**PERUQUE CROSSING  
PHILLIPS 66**

**H.D.P.E. PIPE DETAIL**

BAX PROJECT NAME : PHILLIPS 66 PERUQUE CROSSING  
 BAX PROJECT NO. : 00-11282M  
 DESIGN DATE : 9-20-06  
 DESIGNED BY : SWR  
 1.5 YEAR HYDRAULICS  
 SUBMITTED: 9-21-06 FILENAME: 11282M

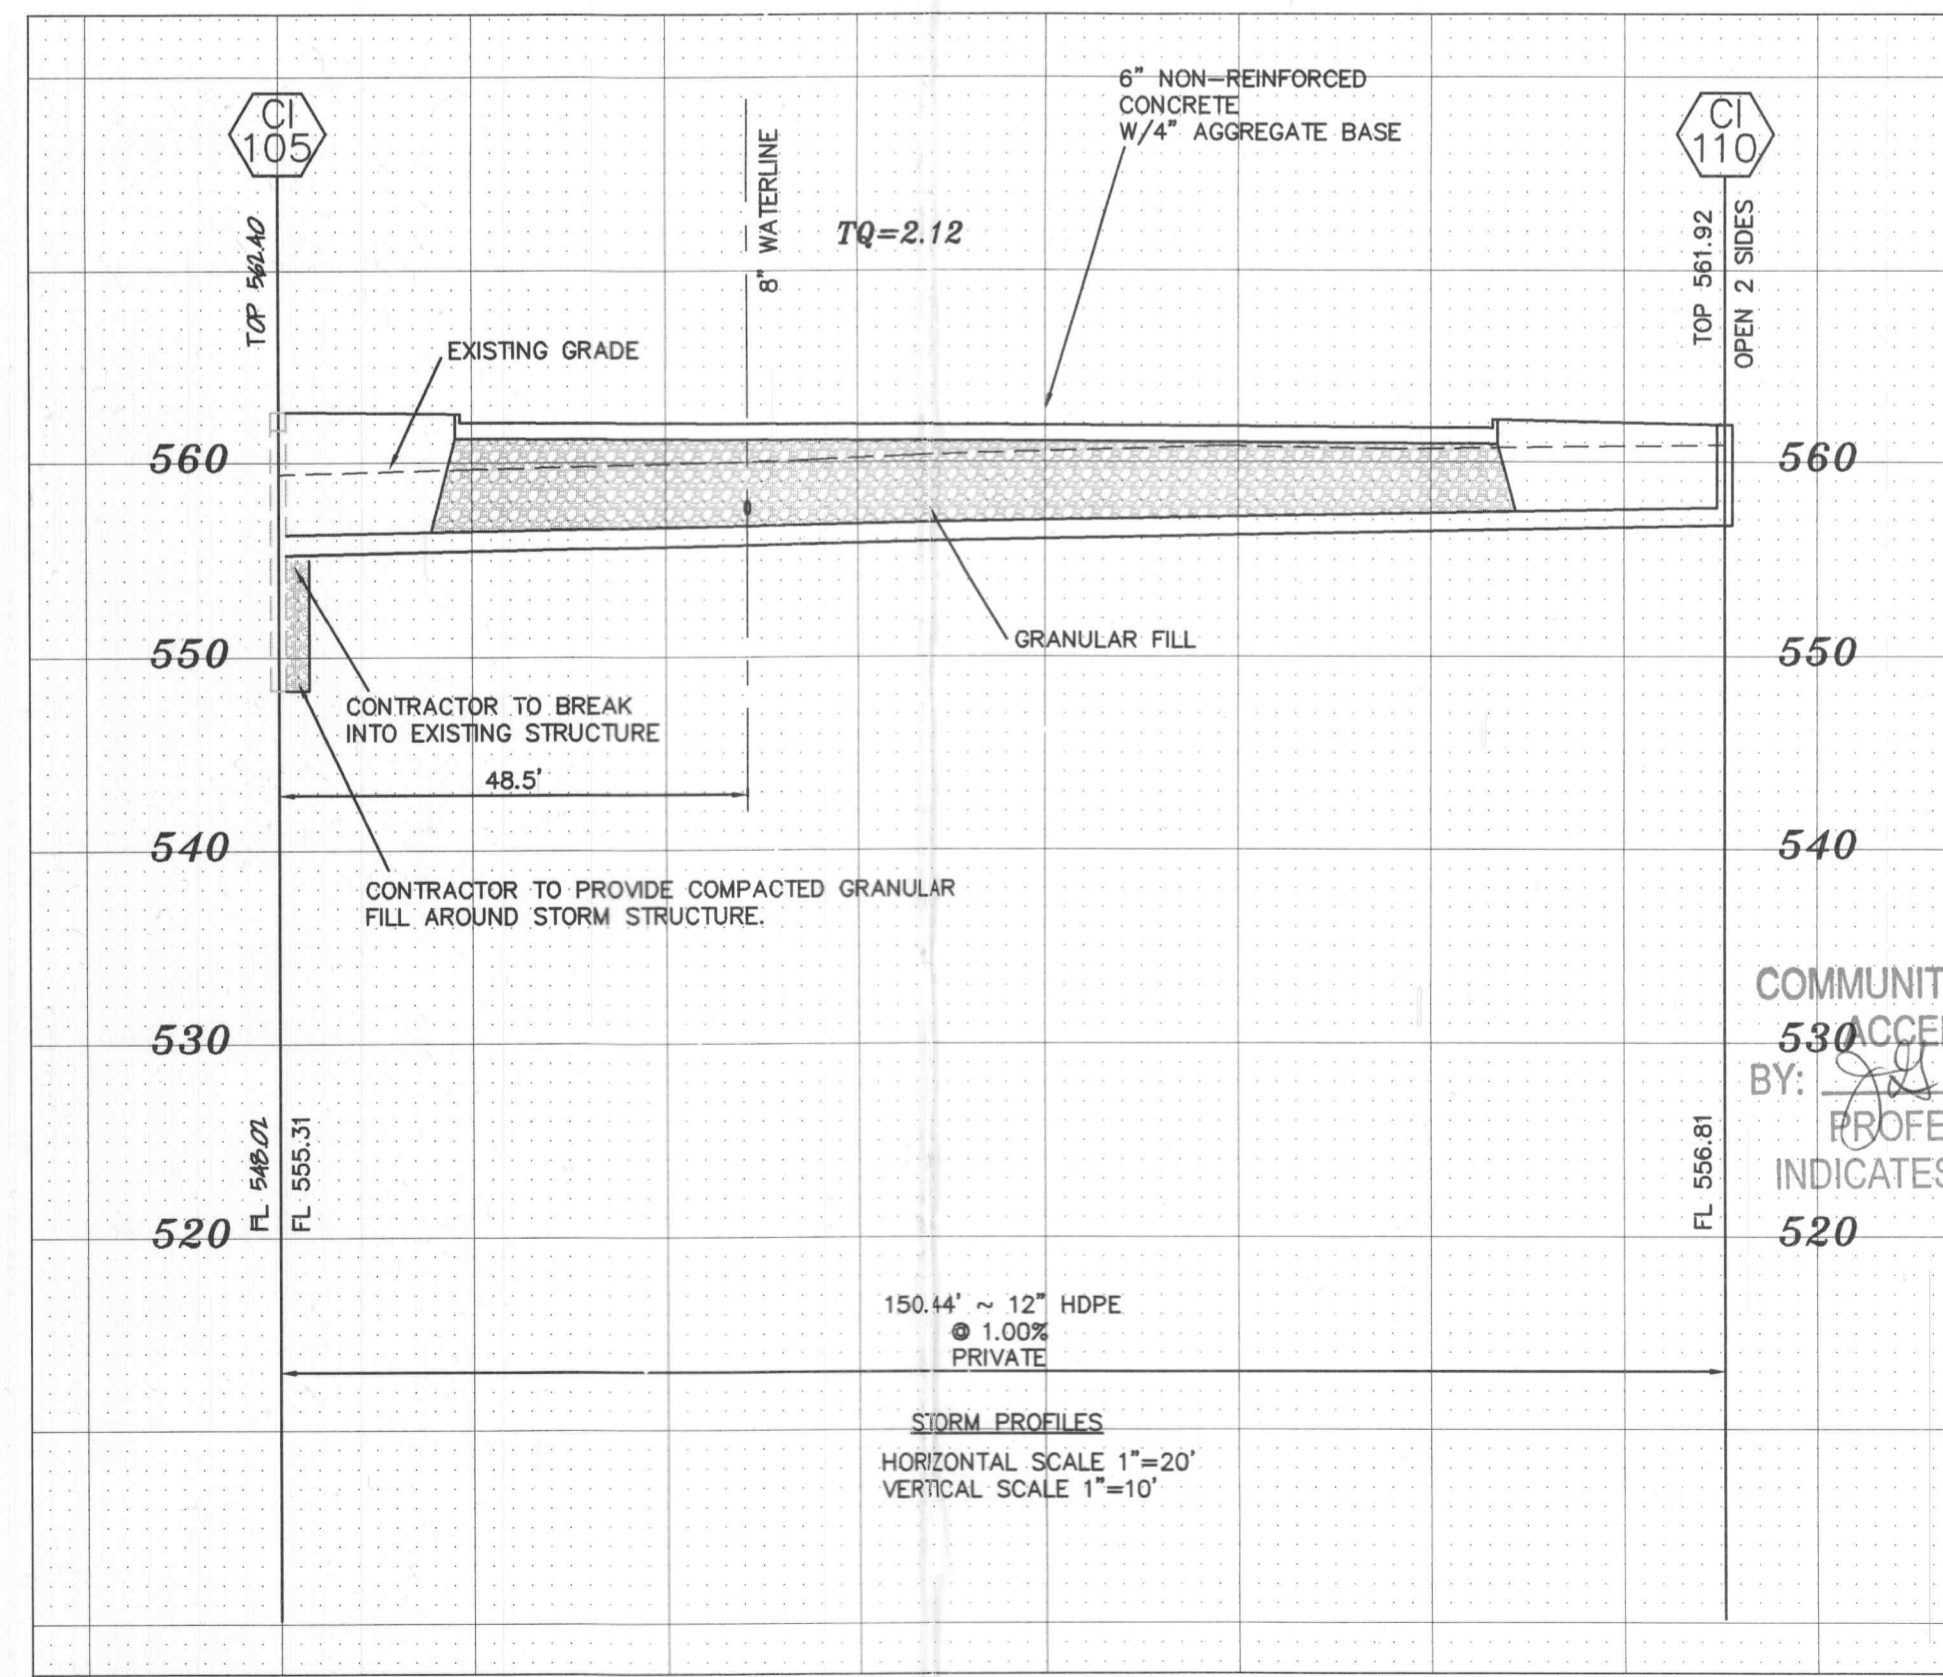
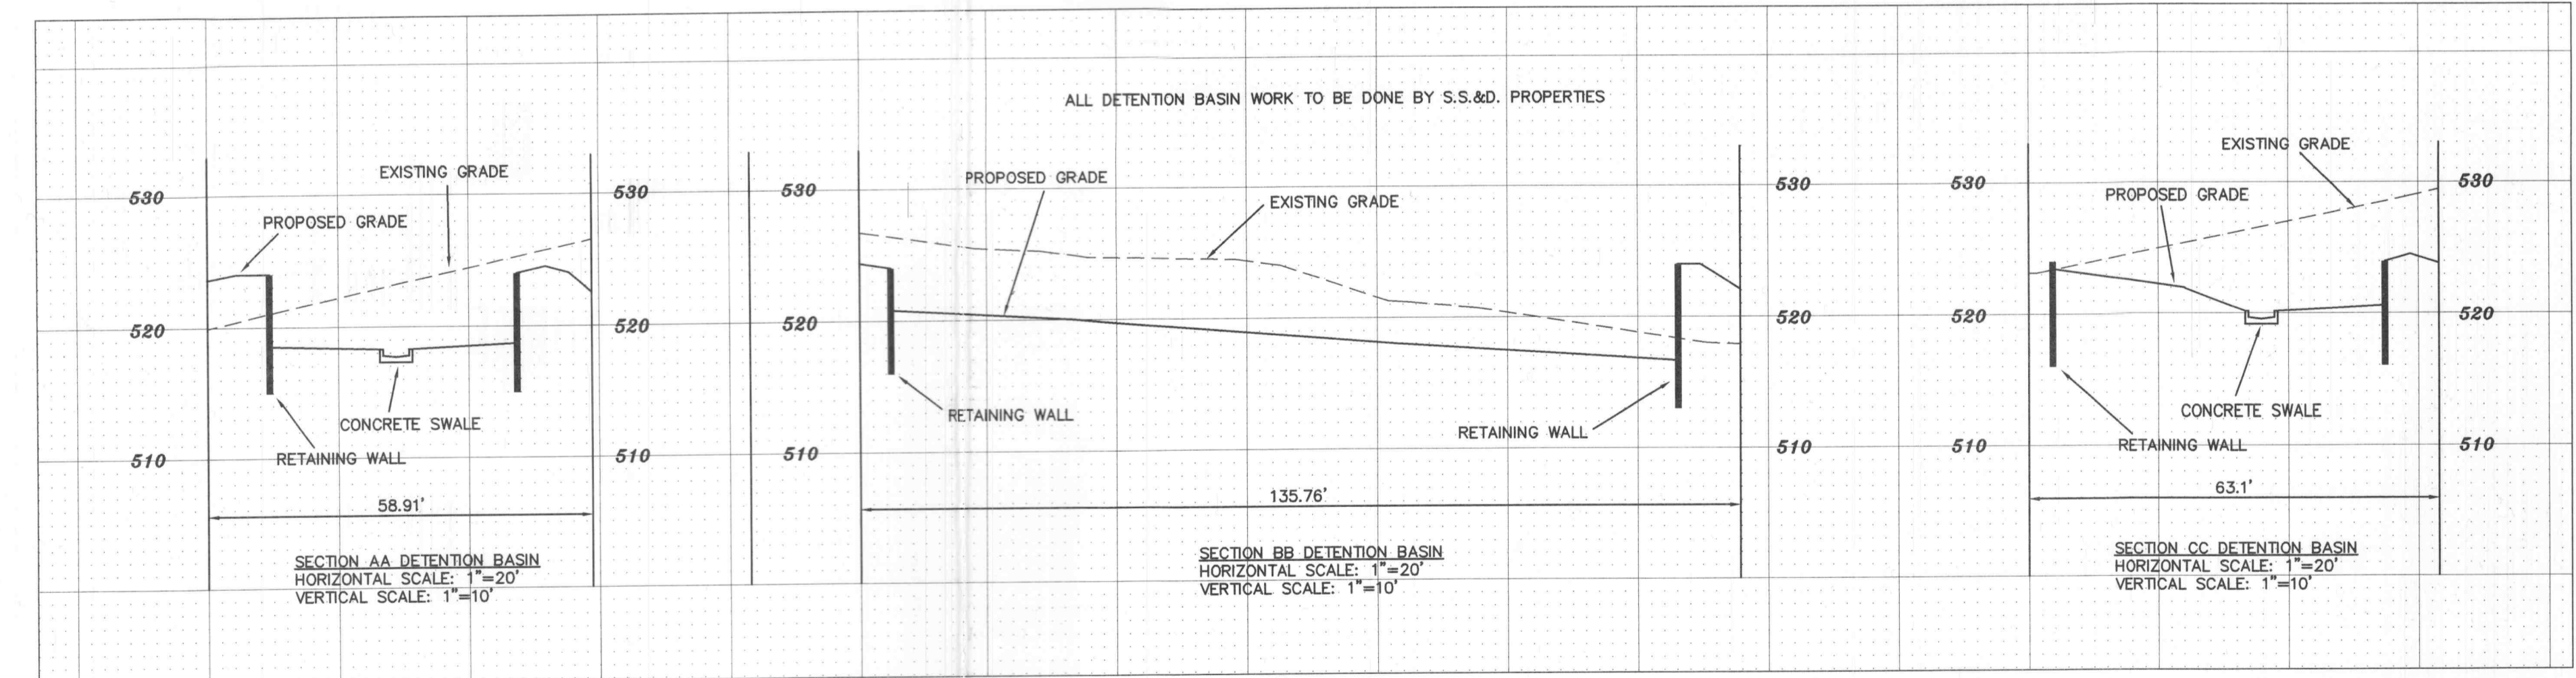
HDPE pipe is to be N-12WT or equal and to meet ASTM F1417 water tight field test.
